**PLANNING COMMISSION  
MEETING  
April 1, 2024  
4:00 PM**

**Administrative Staff Report**  
**Site Plan & Architectural Review**  
**Valvoline LLC – Oil Change Service**  
**1140 East Riverview Expressway**  
**March 28, 2024**

The applicant, Valvoline LLC, is requesting a site plan review to construct a new oil change service shop located at 1140 East Riverview Expressway. The property is zoned as General Commercial (B-2) District.

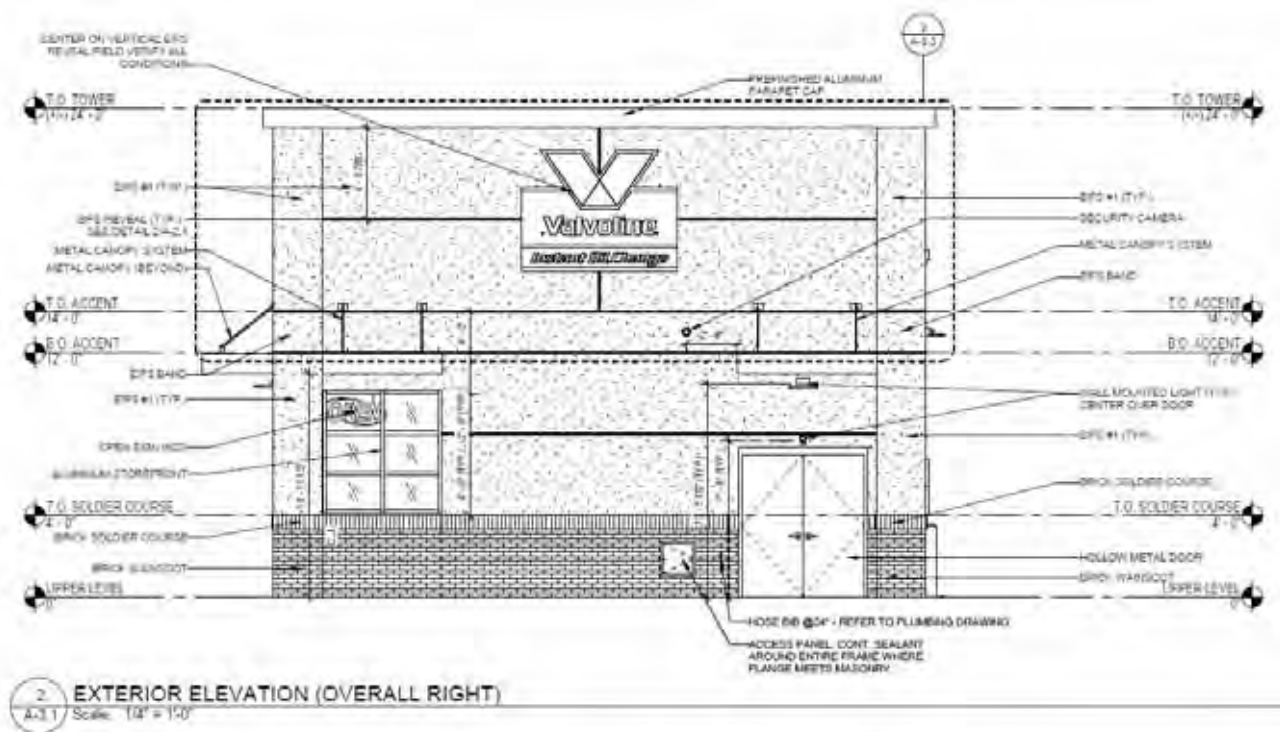
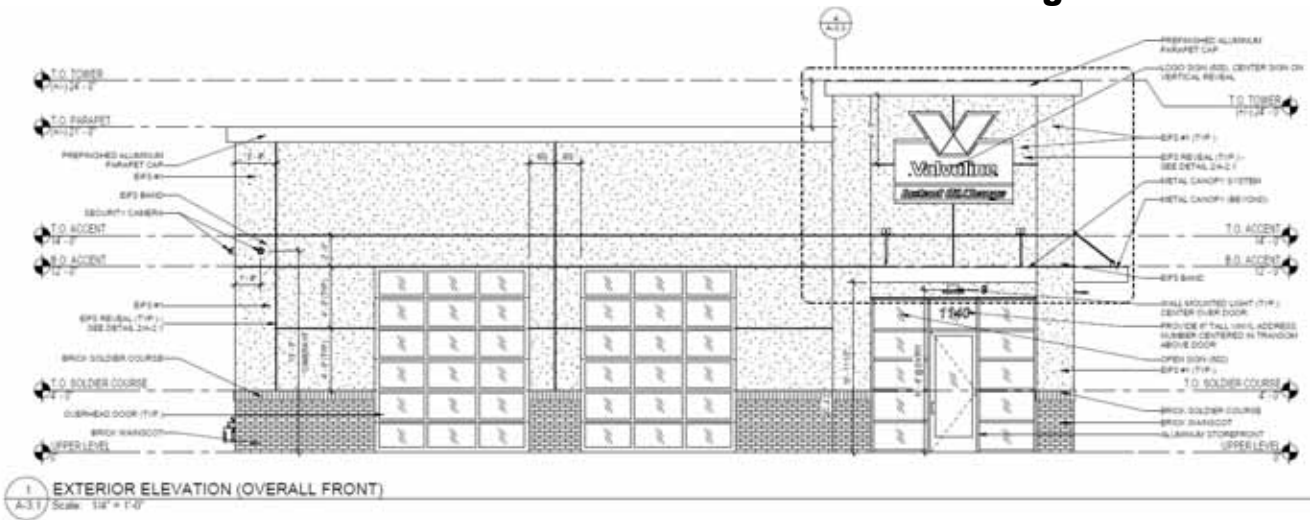
**Findings:** Existing wooded vegetation will assist in screening the use from the roadway and can be utilized to meet the street frontage landscaping requirements. Staff would recommend an updated landscaping plan be provided after the existing vegetation is surveyed by a landscape architect to ensure street frontage plantings are met.

Building foundation plantings meet the landscape requirement. A mixture of tall trees and shrubs are proposed throughout the parking area to meet the parking lot landscape requirements. The keeping of existing mature street trees, and the plans for additional street frontage trees shall create a good aesthetic buffer of the use between surrounding uses.

PHOTOMETRIC PLAN

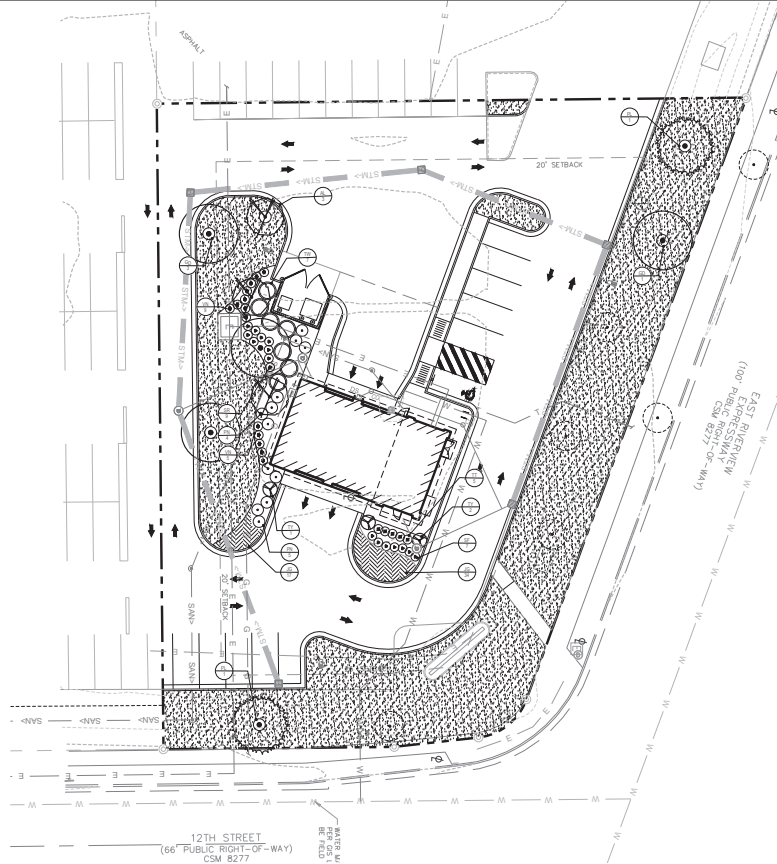
**Findings:** The lighting plan mainly identifies 0.0-foot candle trespass at the property lines; however there are measurements in excess of the requirement. Staff recommend an updated plan showing the reduction in lighting amounts, showing they do not exceed 0.2 foot candles on property lines with adjacent commercial uses.
